**75-27-09 R2 BEECH:** Amendment 39-2482 as amended by Amendment 39-2591 is further amended by Amendment 39-3878. Applies to all Beech 18 series airplanes including military counterparts and other counterparts approved by Supplemental Type Certificates (STCs), regardless of the category or categories of airworthiness certification.

COMPLIANCE: Required as indicated. To prevent possible failure of wing structure, accomplish the following for the left and for the right sides of each affected airplane.

FIGURE 2

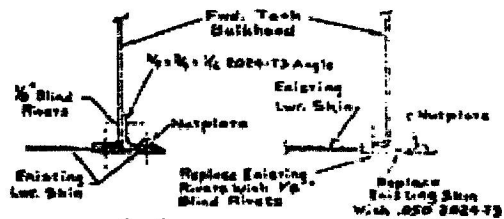
B) At the time of the next inspection of wing structure that is required by this directive, unless previously accomplished, incorporate inspection access provisions in accordance with Figure 2, below, or a Federal Aviation Administration (FAA)-approved equivalent. If additional access provisions are necessary for inspection of sites specified by reports per Subparagraph C)7., below, follow instructions from Beech Aircraft Corporation, and incorporate these provisions.

Attach MK1000-3 Nuts (or equiv.) (7 places) as shown by (N). Cut inspection door from .032 2024-T3 Alum. Allow  $\frac{1}{8}$ " edge margin around all screws (sic). Install door on lower side with #10 screws (25 places); cut three holes for jacked nuts. Inspection door not shown.

FIGURE 3 AD 75-27-09

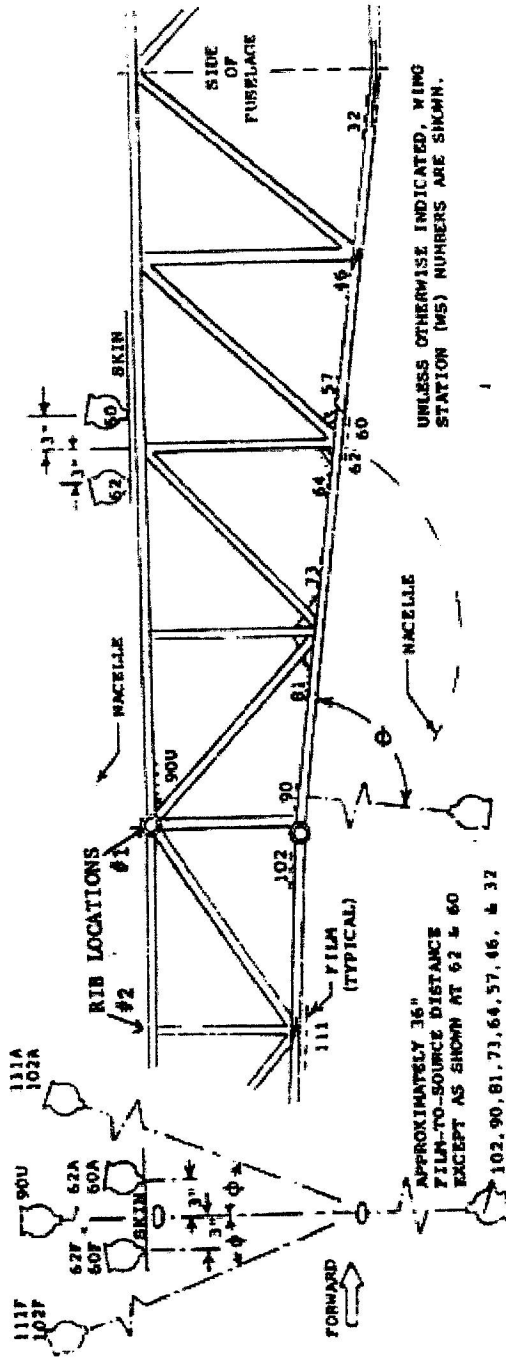
d) After the wing is loaded, ascertain that the X-ray source is secured against the upper wing skin for WS 60 and 62 sites and approximately 36 inches from the film at all other sites, at chordwise and spanwise angles specified by Figure 3 of this directive.

THE CHORD-WISE AIMING ANGLE,  $\phi$ , IS BETWEEN PLANE OF SPAR AND X-RAY BEAM CENTERLINE. POSITION TAIL OF AIRPLANE AND/OR USE FIXTURE (AND C. CK WITH PROTRACTOR OR FLASHLIGHT) TO KEEP ANGLE  $\phi$  AT:

NOMINAL OF 0° (NO ABSOLUTE LIMIT) FOR MS 32, 46, 57, 64, 73, 81, 90, & 102. MS 102 MAY BE TAKEN WITH SOURCE EITHER ABOVE OR BELOW THE LOWER SPAR CAP. MS 57 & 64 NEED NOT BE TAKEN SEPARATELY IF PLAINLY SHOWN BY MS 60 & 62 FILMS.

BETWEEN 20° AND 45° FOR FORWARD AND AFT SHOTS OF MS 111 & (OPTIONALLY) 102.

AS DRAWN FOR FORWARD & AFT SHOTS OF MS 60 & 62.

THE SPANNISE AIMING ANGLE,  $\phi$ , IS BETWEEN THE SPAR CAP AND X-RAY BEAM CENTERLINE, AS SHOWN. POSITION AIRPLANE MAIN WHEEL AND/OR USE FIXTURE TO KEEP ANGLE  $\phi$  AT:

BETWEEN 85° AND 95° FOR MS 32, 46, 57, 64, 73, 81, 90, 102, AND 111.

NOMINALLY 90° (NO ABSOLUTE LIMIT) FOR MS 90U

AS DRAWN FOR MS 60 & 62

FIGURE 4 AD 75-77-09

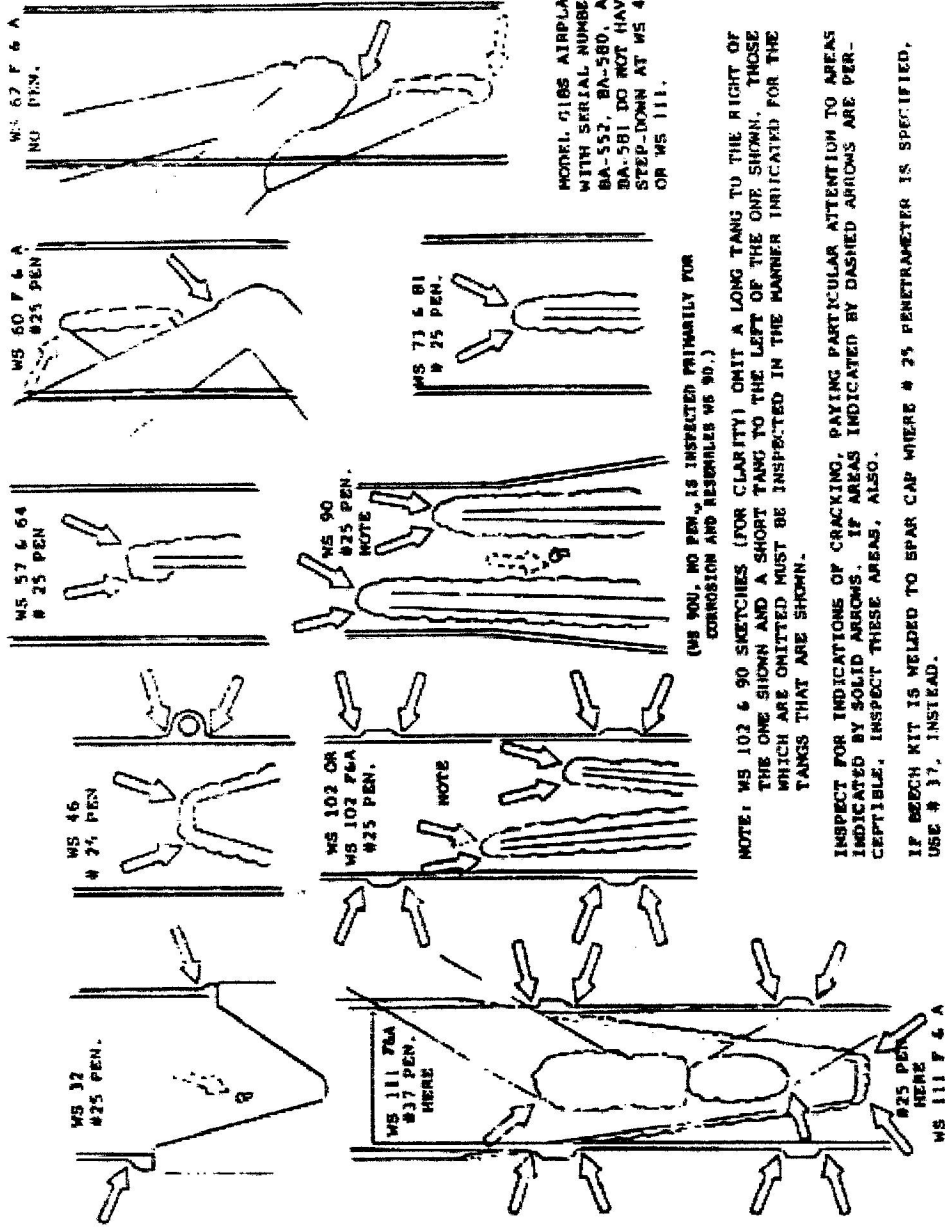
surface of cap	magnetic particle or penetrant
60 and 62	Tips of welds as shown in Figure 4	X-ray
61	Lower surface of spar cap below tube cluster, as seen from wheel well	Visual and either magnetic particle or penetrant
90	Tips of welds at clevis tangs, upper and lower surface	Visual, X-ray and either magnetic particle or penetrant
90U	Tips of welds at clevis tangs, upper and lower surface	X-ray
102 & 111	Tips of welds as shown in Figure 4	X-ray

e) Ascertain that neither the airplane nor the source will be moved by wind or other influences, and expose the film so as to obtain 1.5 to 2.8 radiographic density near inspection sites specified in Figure 4 of this directive. Use the same kinds of film and exposure time for WS 62 sites as for WS 60 sites.

MODEL 5185 AIRPLANES WITH SERIAL NUMBERS BA-552, BA-580, AND BA-581 DO NOT HAVE STEP-DOWN AT MS 46 OR MS 111.

(MS 90, NO PEN., IS INSPECTED PRIMARILY FOR CORROSION AND RESORLES MS 90.)

NOTE: MS 102 & 90 SKETCHES (FOR CLARITY) OMIT A LONG TANG TO THE RIGHT OF THE ONE SHOWN AND A SHORT TANG TO THE LEFT OF THE ONE SHOWN. THOSE WHICH ARE OMITTED MUST BE INSPECTED IN THE MANNER INDICATED FOR THE TANGS THAT ARE SHOWN.

INSPECT FOR INDICATIONS OF CRACKING, PAYING PARTICULAR ATTENTION TO AREAS INDICATED BY SOLID ARROWS. IF AREAS INDICATED BY DASHED ARROWS ARE PERCEPTIBLE, INSPECT THESE AREAS, ALSO.  
IF BEECH KIT IS WELDED TO SPAR CAP WHERE # 25 PENETRATOR IS SPECIFIED, USE # 37, INSTEAD.
